# *City of Brisbane*

## *Planning Commission Agenda Report*

**SUBJECT:** **Sign Program Modification SR-1-20 (Amendment to SR-7-19);** Sign Program Modification to “The Shore at Sierra Point Sign Program” for the HealthPeak Biotechnology Research and Development Campus; 800 to 1800 Sierra Point Parkway; Kevin Norman, DES Architects + Engineers, Inc., applicant; Scott Bohn, HealthPeak Properties, owner

**Sierra Point, Brisbane, CA.**  
Signage Master Plan

**Site Monument**

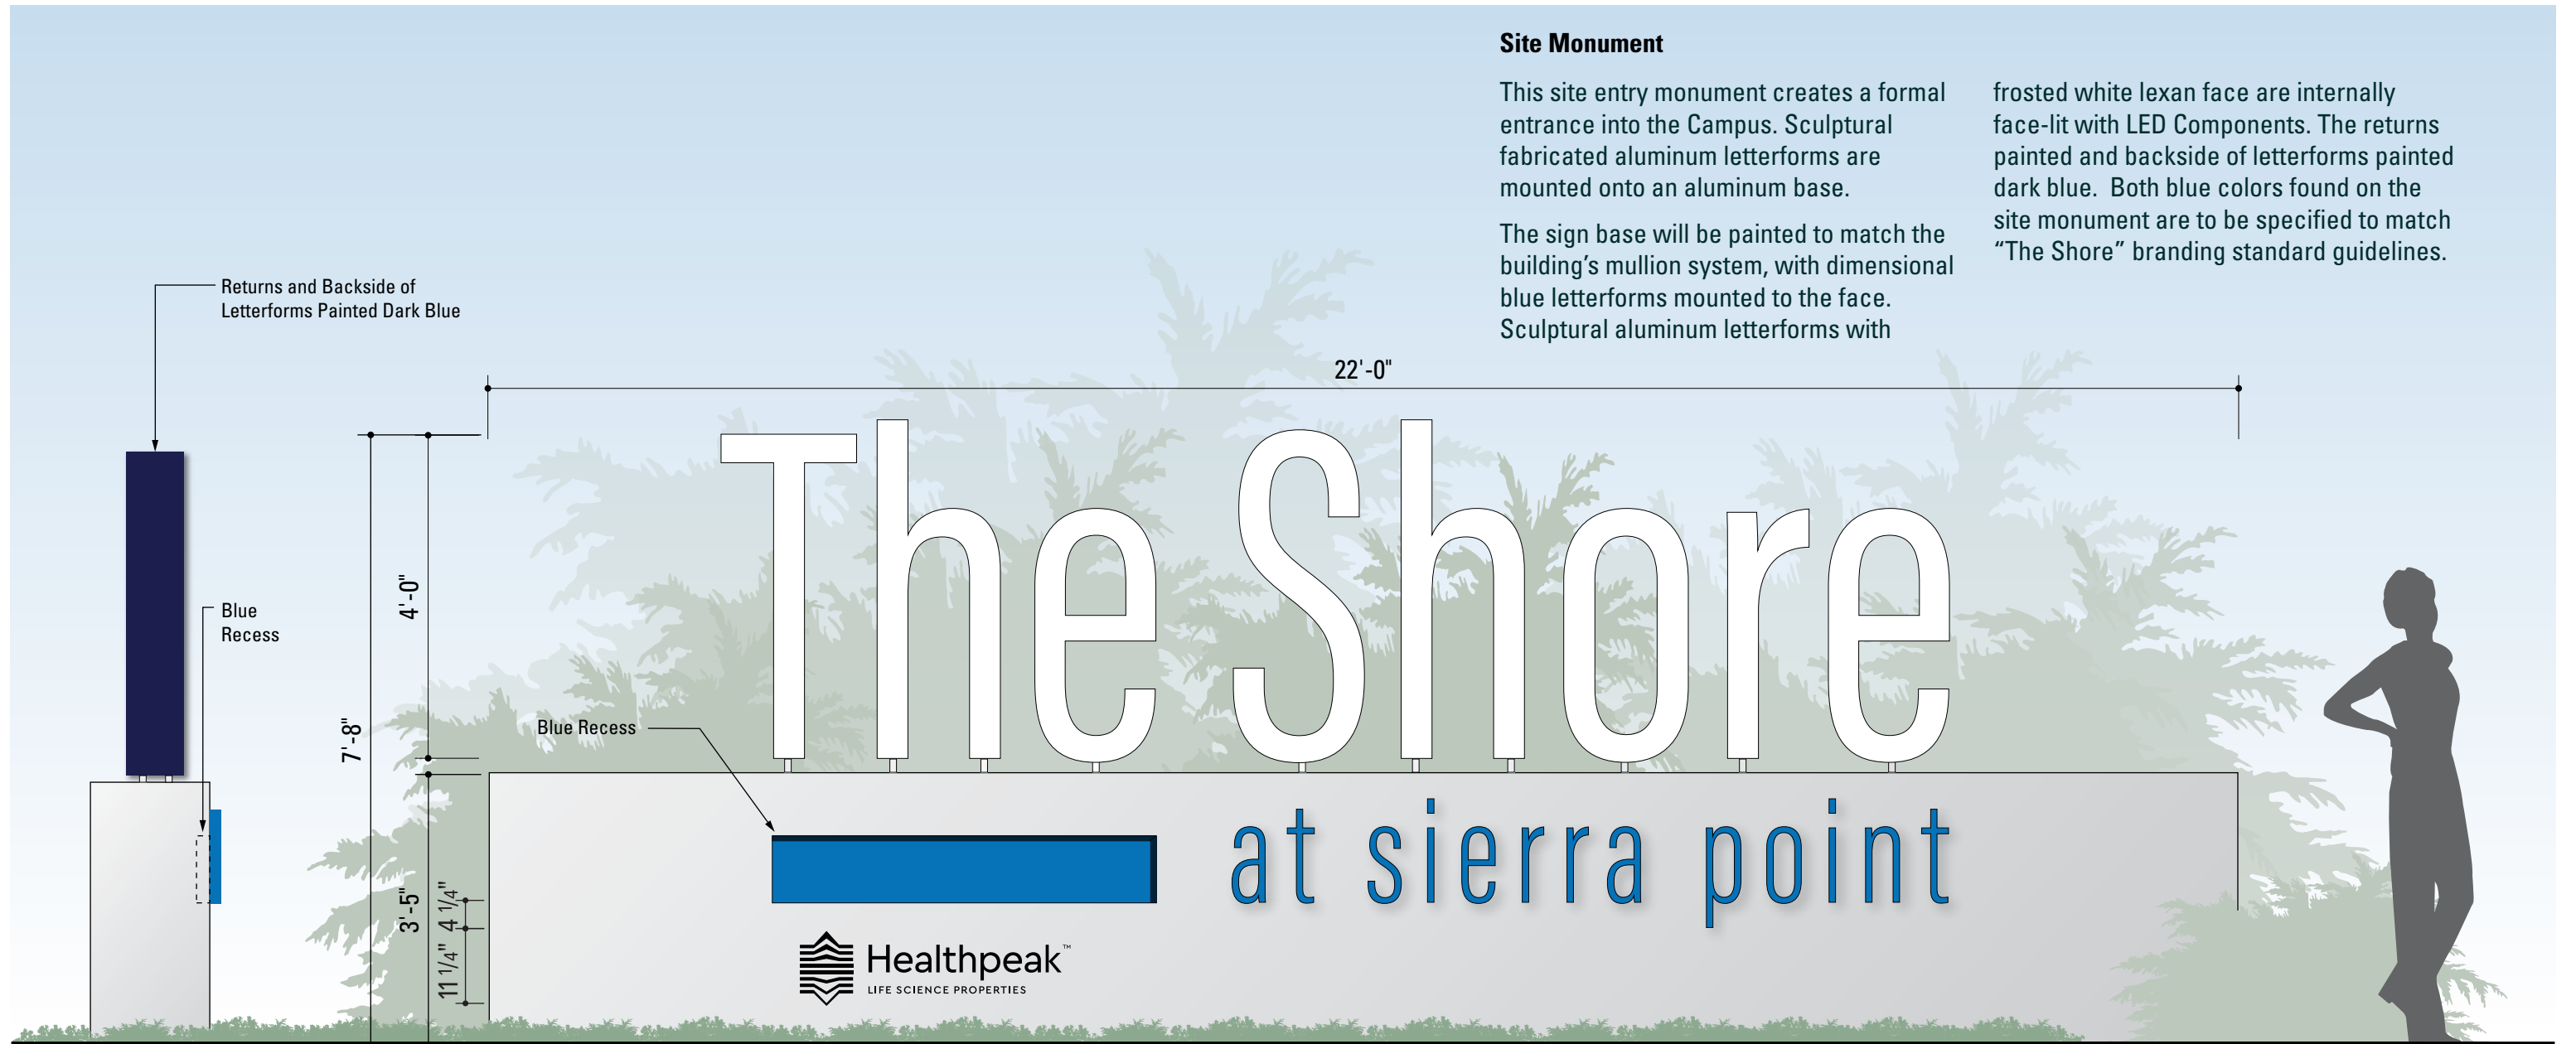
**Updated to reflect change in owner name from HCP to Healthpeak - 7/22/21**

**GROUND SIGNS: ENTRY MONUMENT M2C**

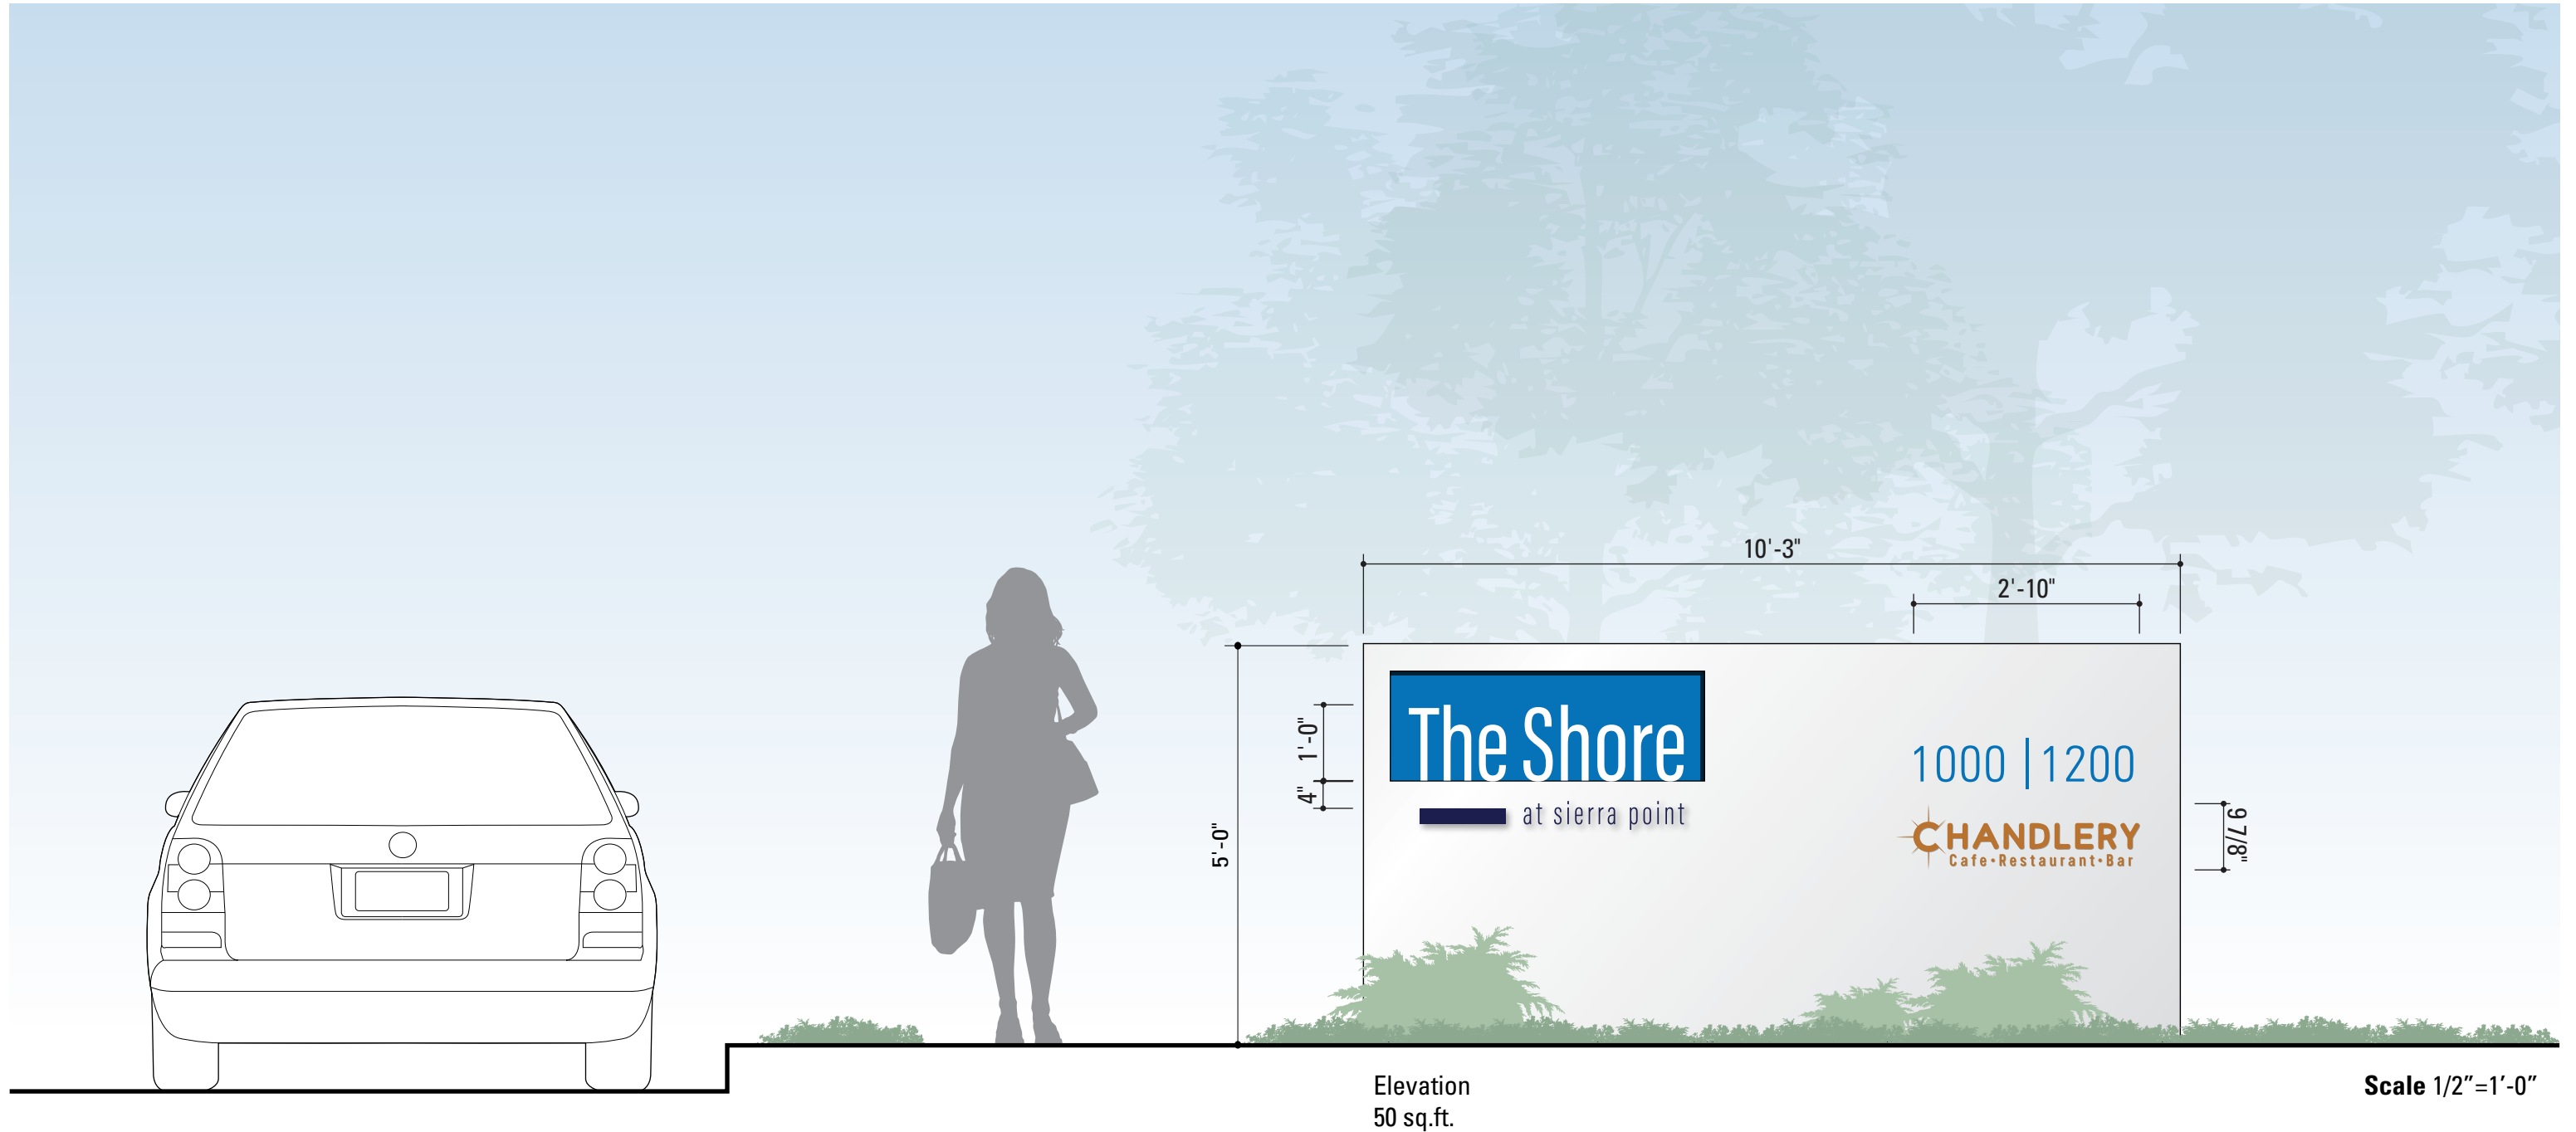
Updated to show change in  
cafe tenant, with graphic  
height increase from 8" to 9 7/8"  
- 7/22/21

**Garage Address**

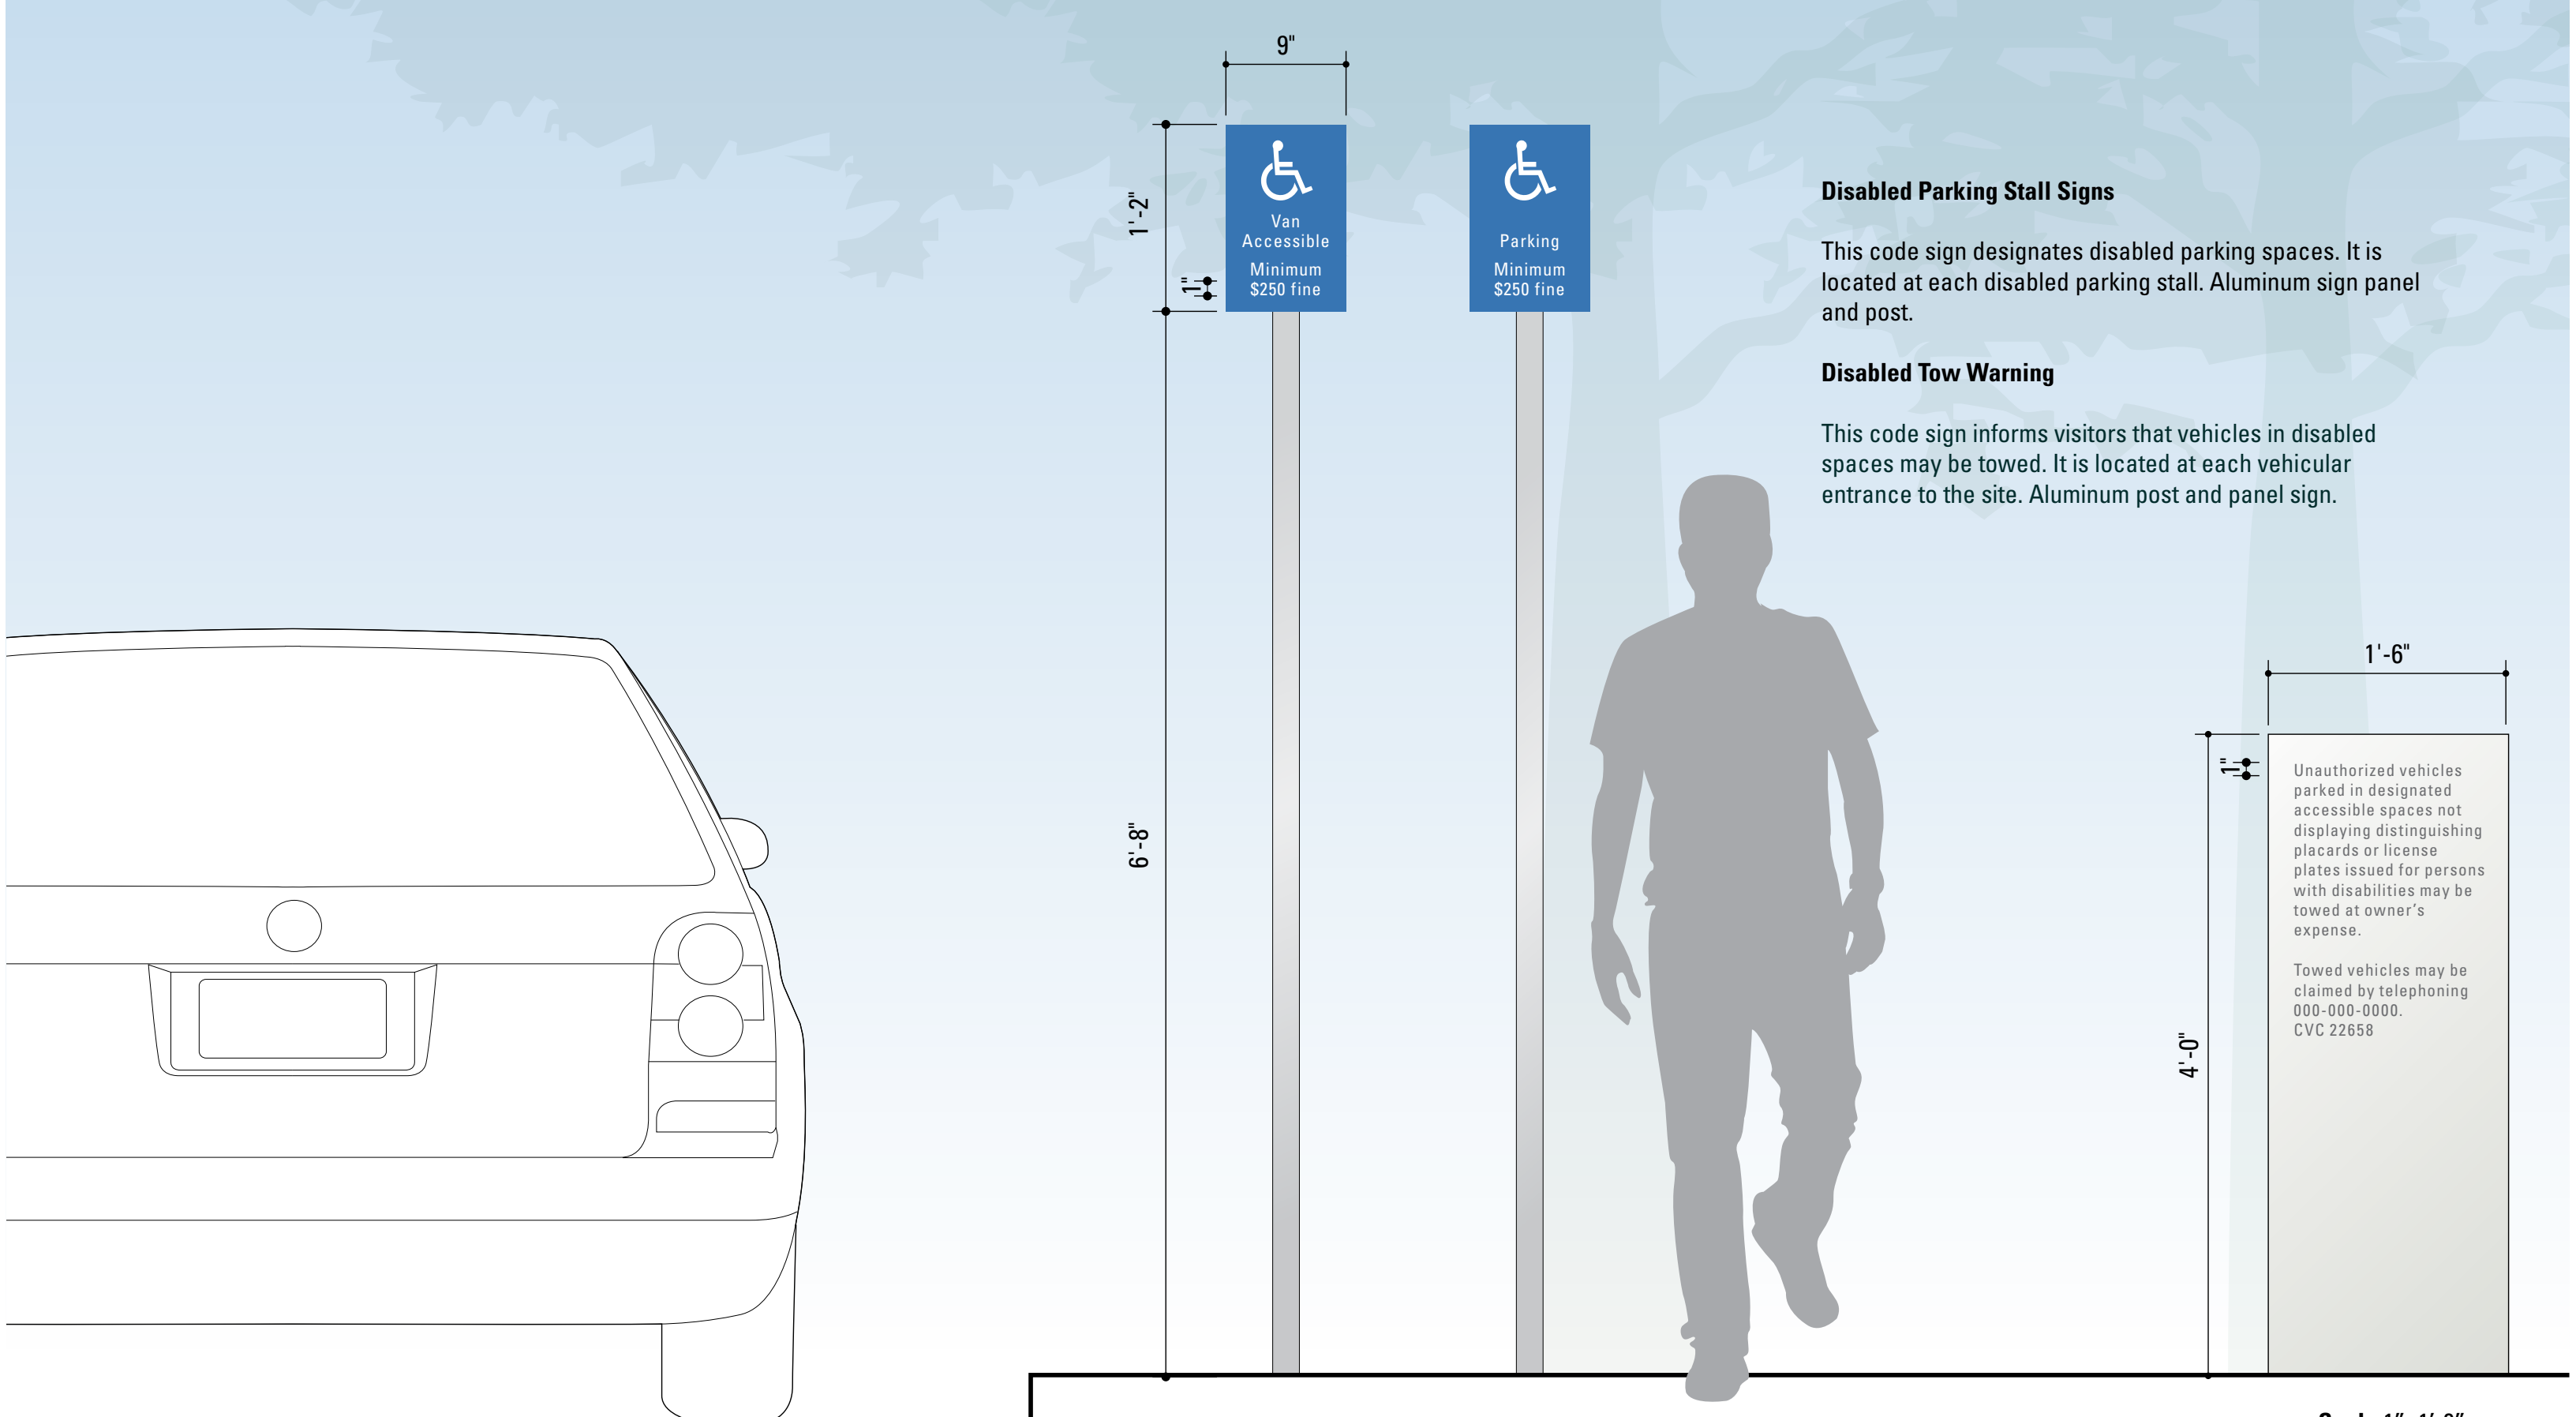
Added to show garage address  
- 7/22/21

This sign is placed at the northwest corner of the garage for visibility in general wayfinding and emergencies. The numerals are aluminum painted to match architectural finishes.
